SOUTHWEST INTERTIE PROJECT

FINAL ENVIRONMENTAL IMPACT STATEMENT and PROPOSED PLAN AMENDMENT

July 1993

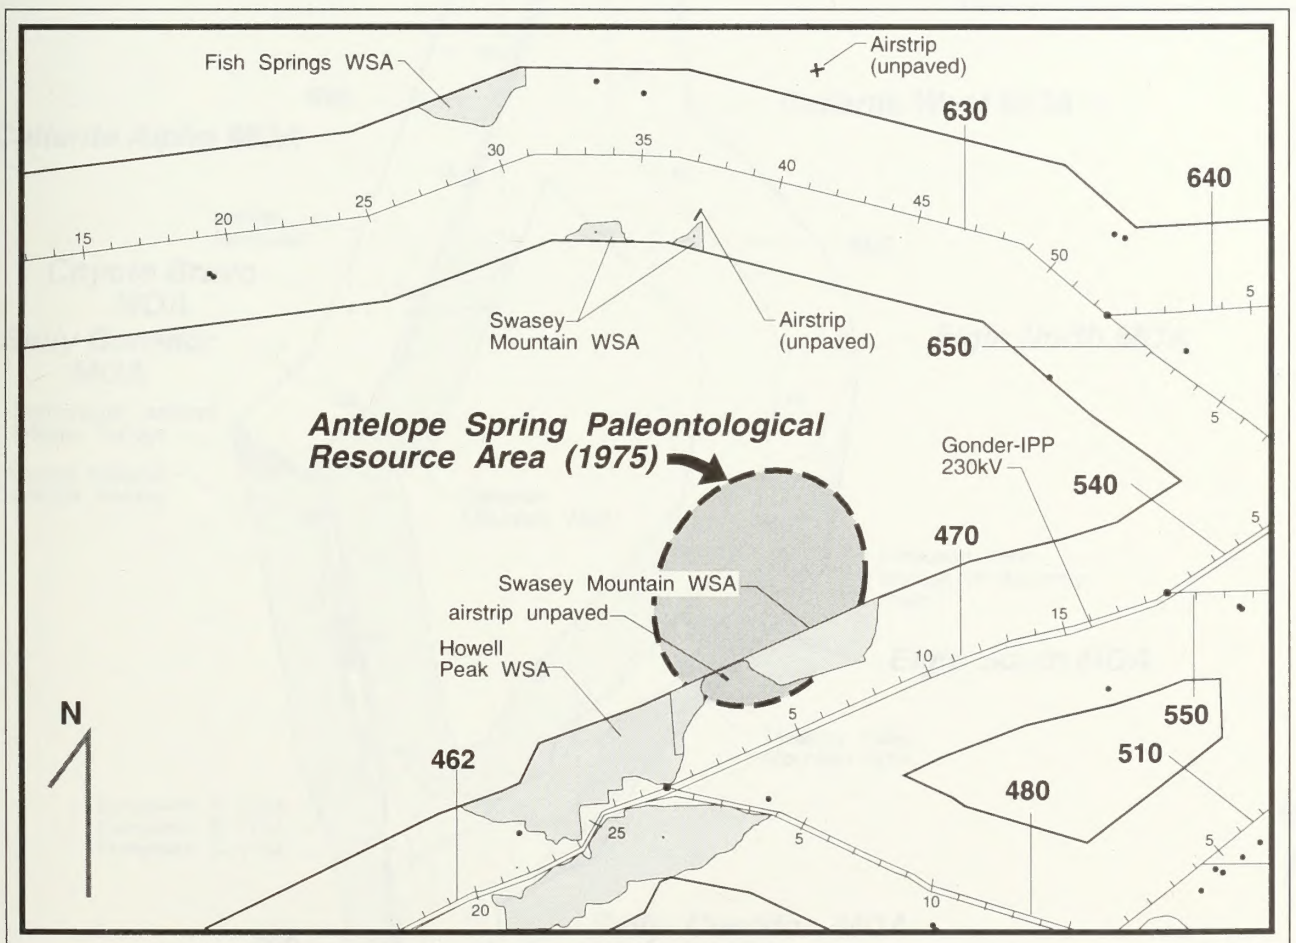
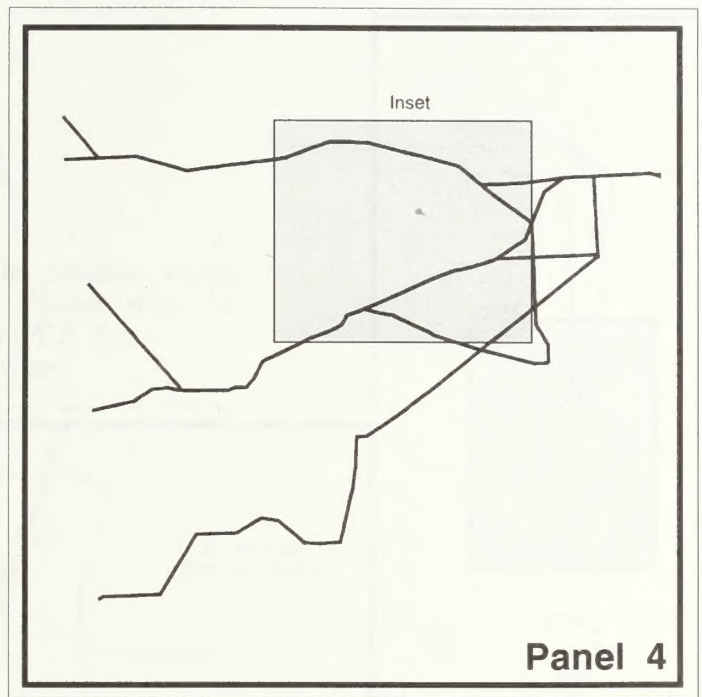
The Antelope Spring Trilobite Beds were not shown on the land use map in the Map Volume accompanying the DEIS/DPA. The boundary of this is illustrated below.

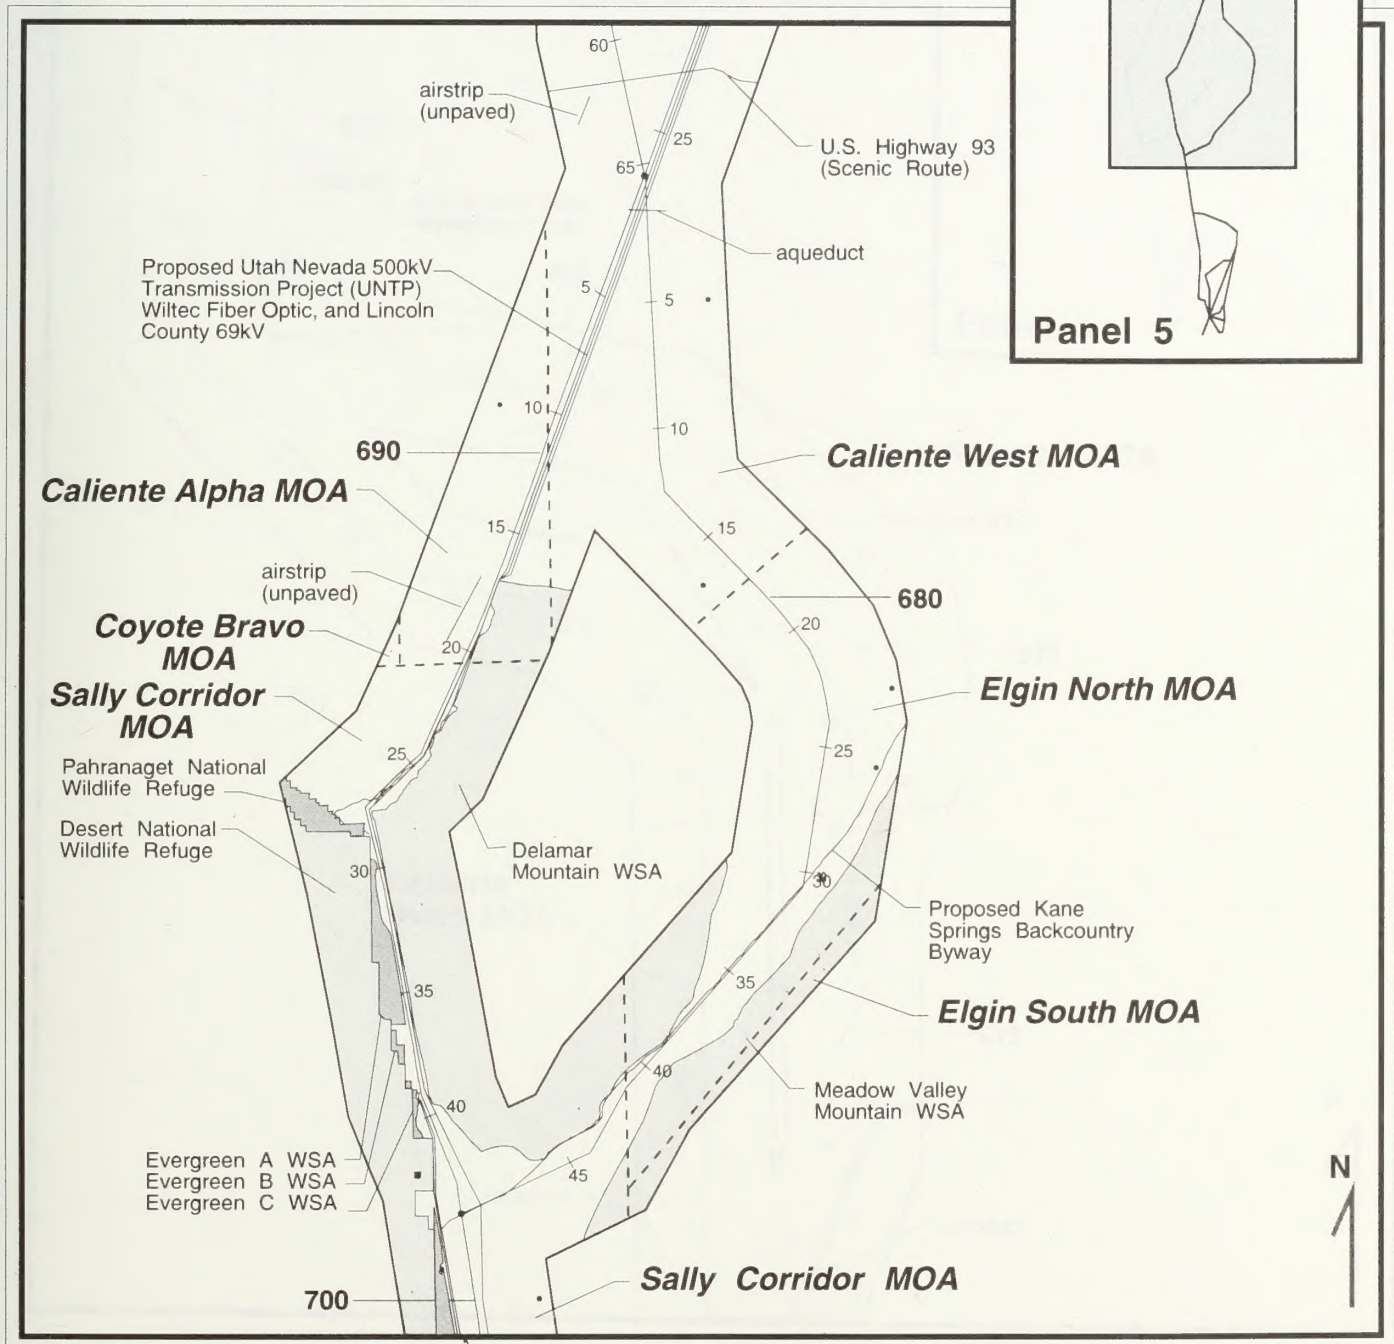
The labels identifying MOAs are missing on this map. These additional labels are illustrated below.

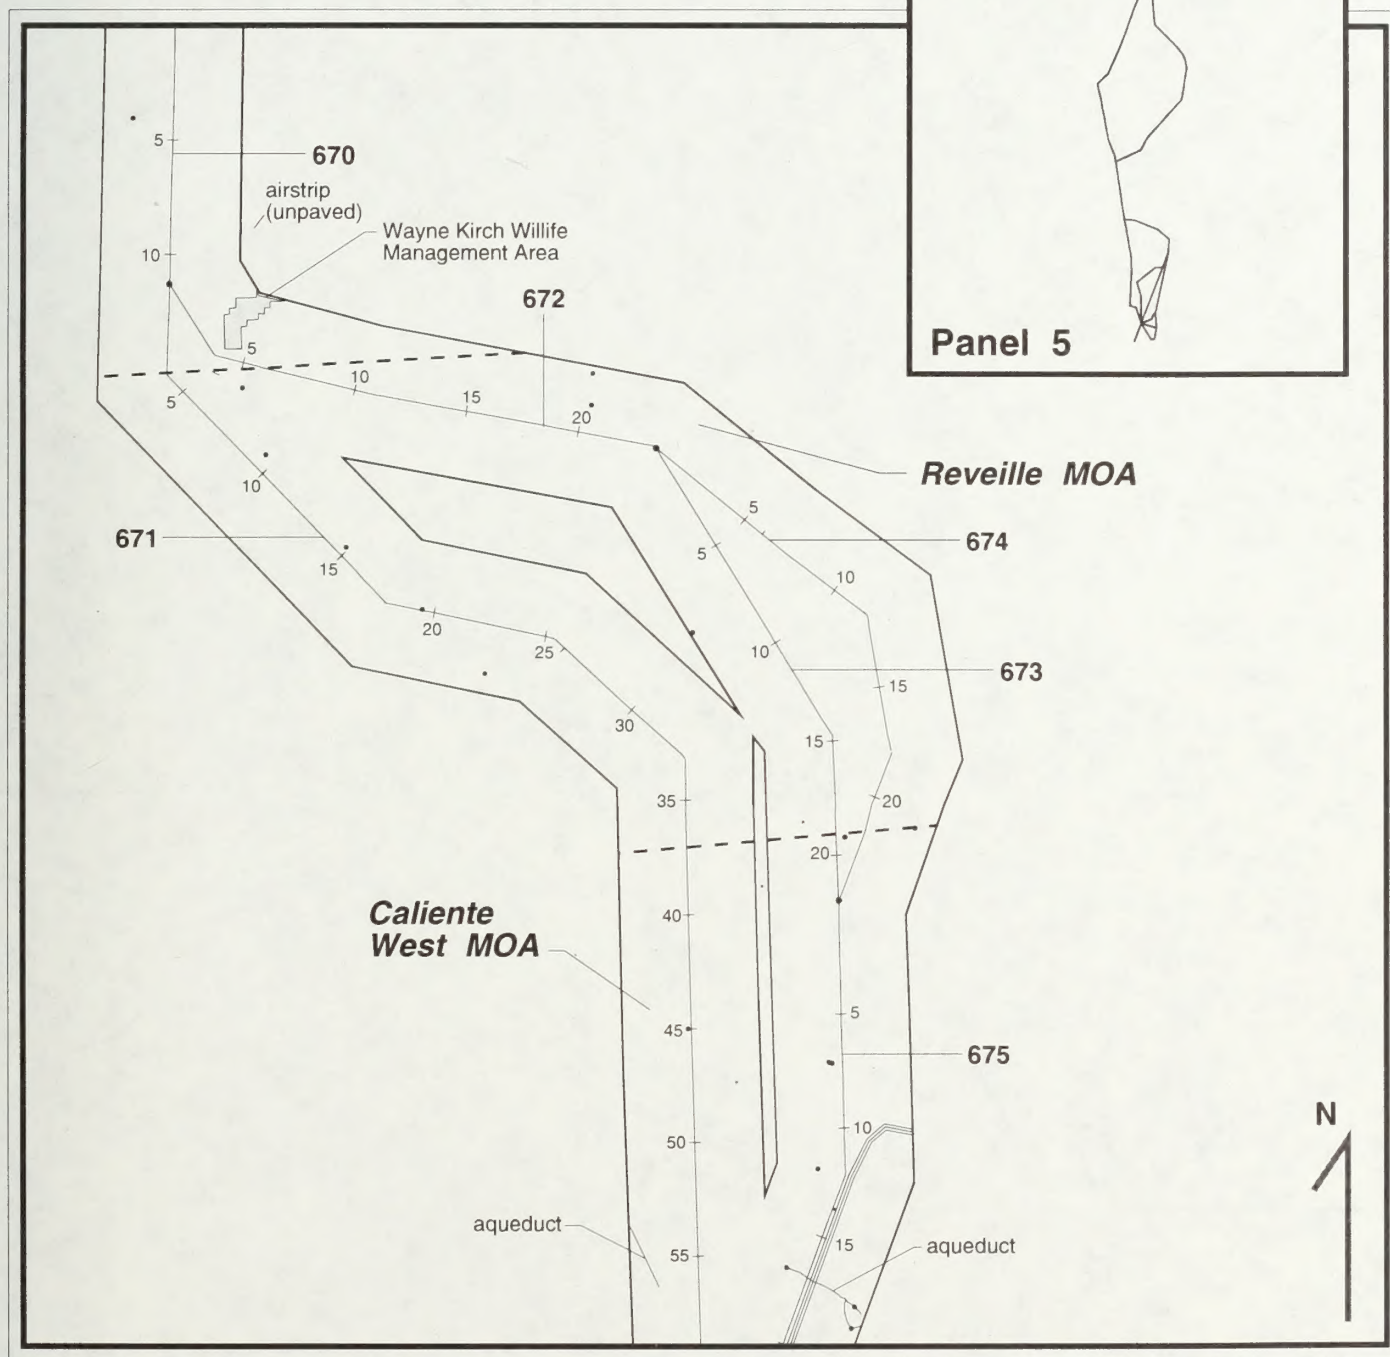
The labels identifying MOAs are missing on this map. These labels are illustrated below.

CORRECTIONS TO: Panel 4 - Jurisdiction

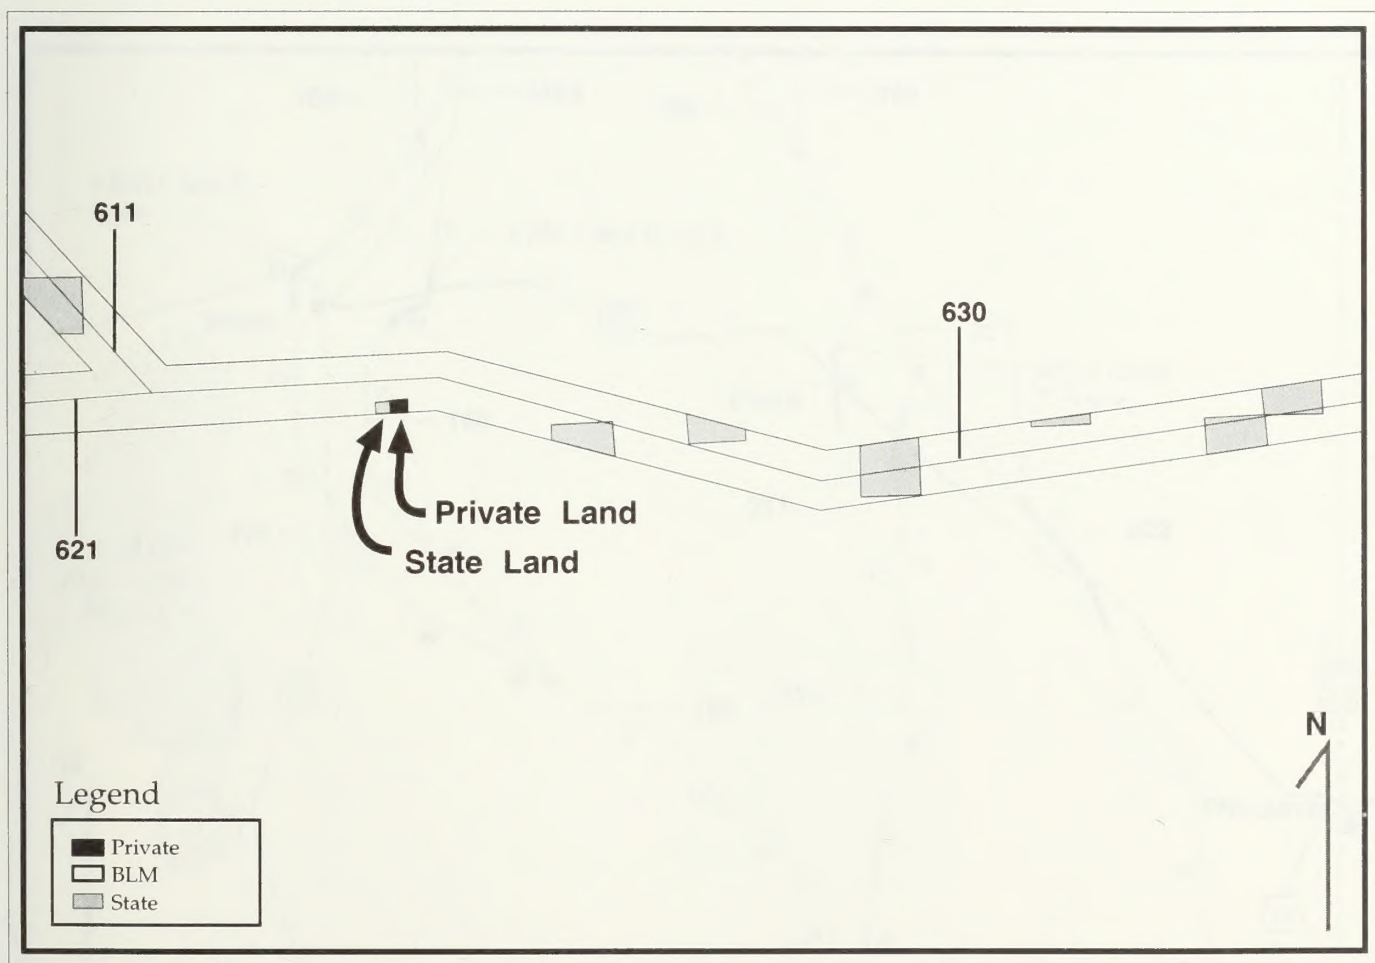
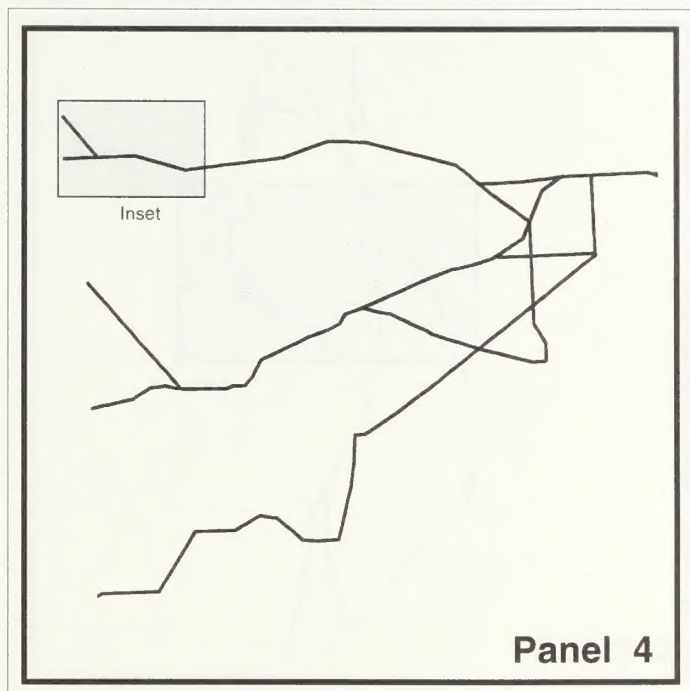
Panel 4 - Jurisdiction Map: This map is missing a small area of State land at T14S, R18W, Section 28, NW1/4, SW1/4 and a small area of private land of T14S, R18W, Section 28, NE1/4, SW1/4, S1/2SW1/4. Figure 4-10 indicates the locations of these parcels.

A small area of State Land at T14S, R18W, Section 28, NW1/4 SW1/4 and a small area of private land at T14S, R18W, Section 28, NE1/4 SW1/4, S1/2 SW1/4 were missing on this map. These lands are illustrated in the map below.

CORRECTIONS TO: Panel 2 - Visual Resources

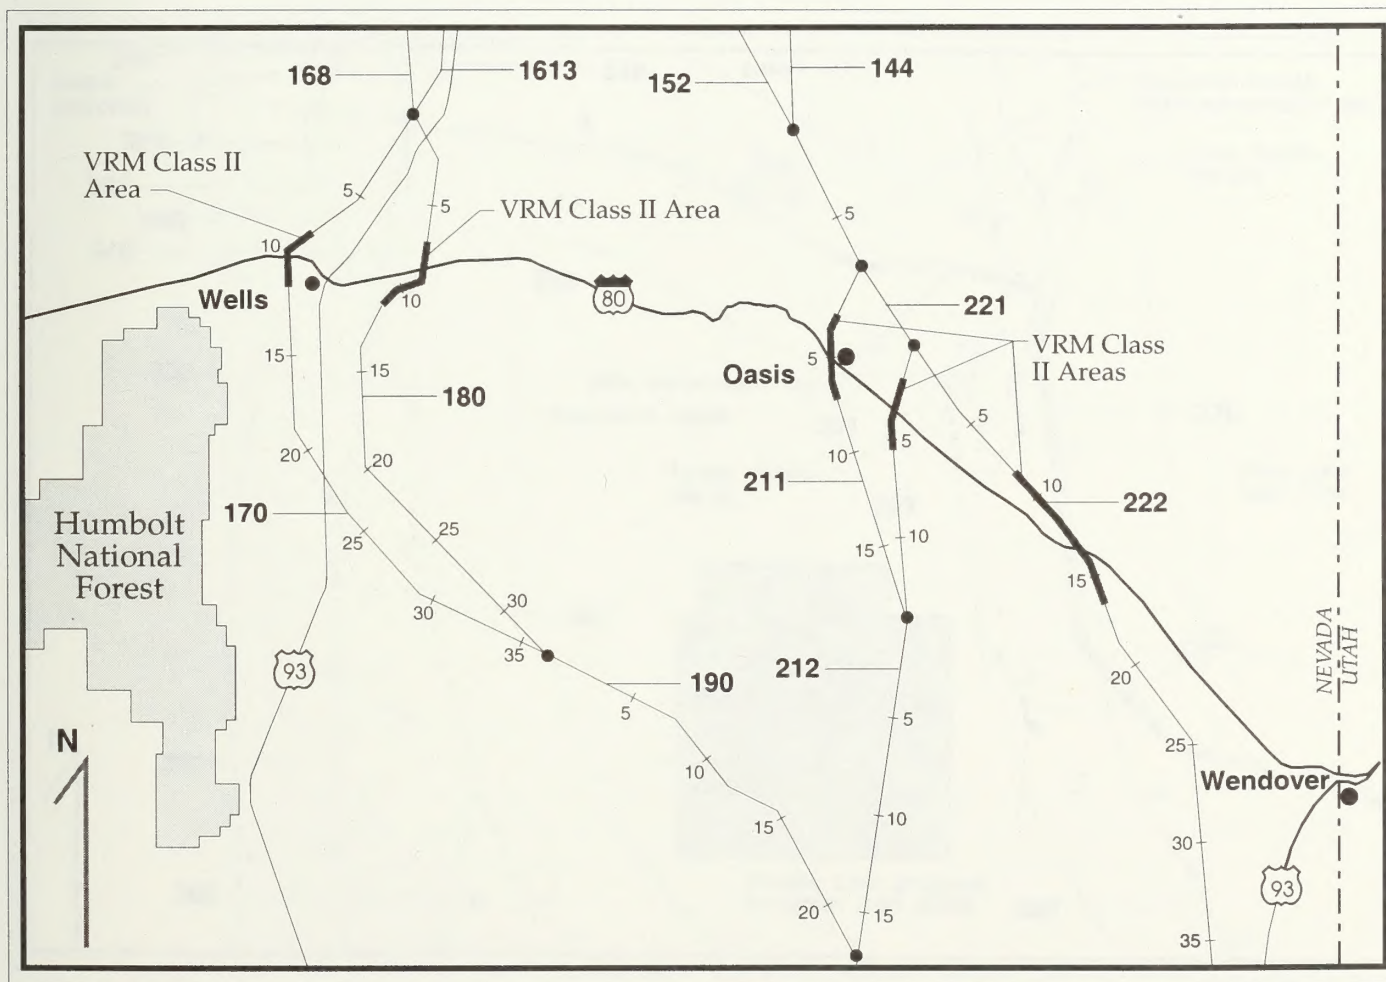
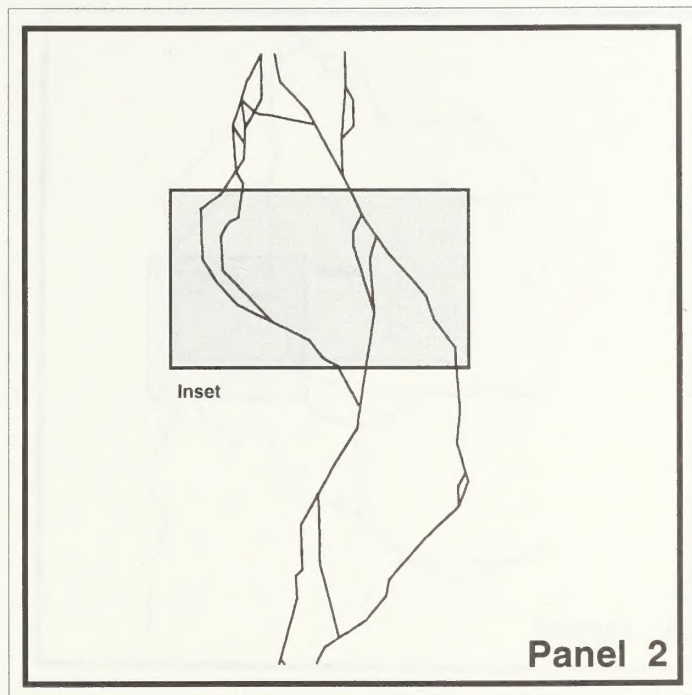
Panel 2 - Visual Resources: The BLM low visibility corridor around Interstate 80 did not appear on the map. The VRM Class II area is shown in Figure 4-11.

This map shows the portion of the alternatives that would cross VRM Class II in the Wells District (Interstate 80 low-visibility corridor).

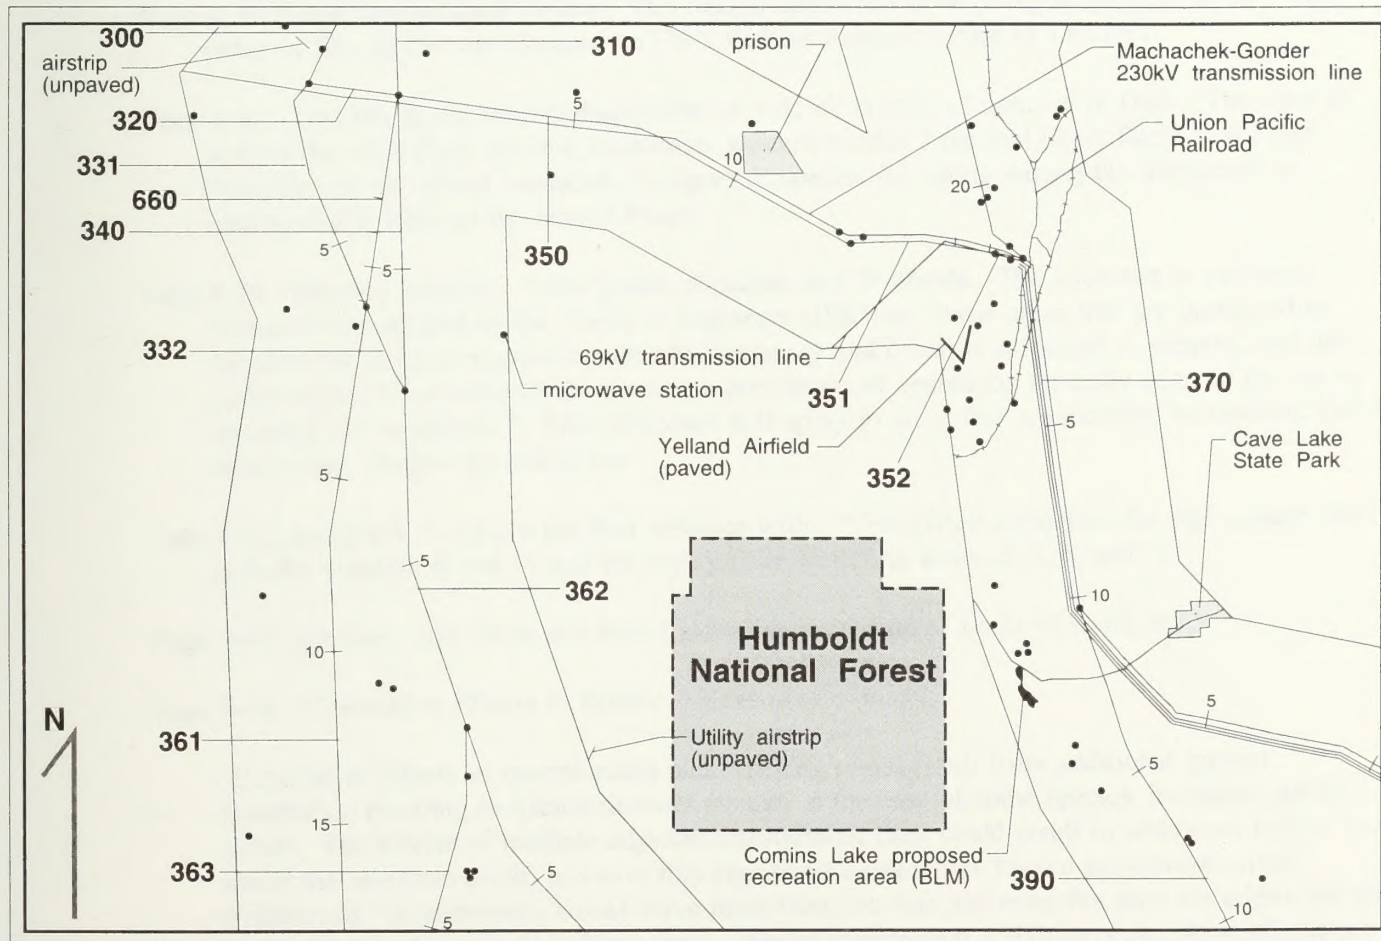
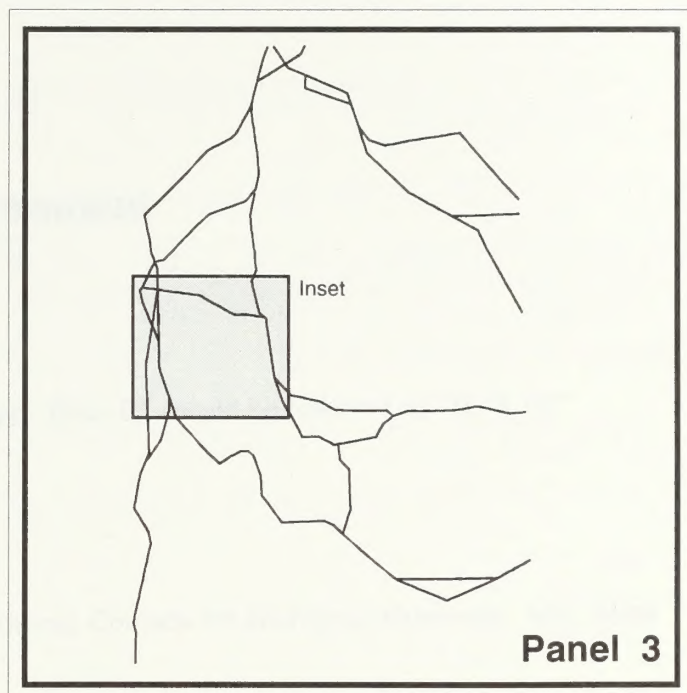
Panel 3 - All Maps: The boundary of the Humboldt National Forest South of Ely was left off of all the Panel 3 Maps. Figure 4-12 shows the approximate location of the boundary.

All Panel 3 maps are missing the Humboldt National Forest Boundary for the area south of Ely. The boundary is illustrated below.
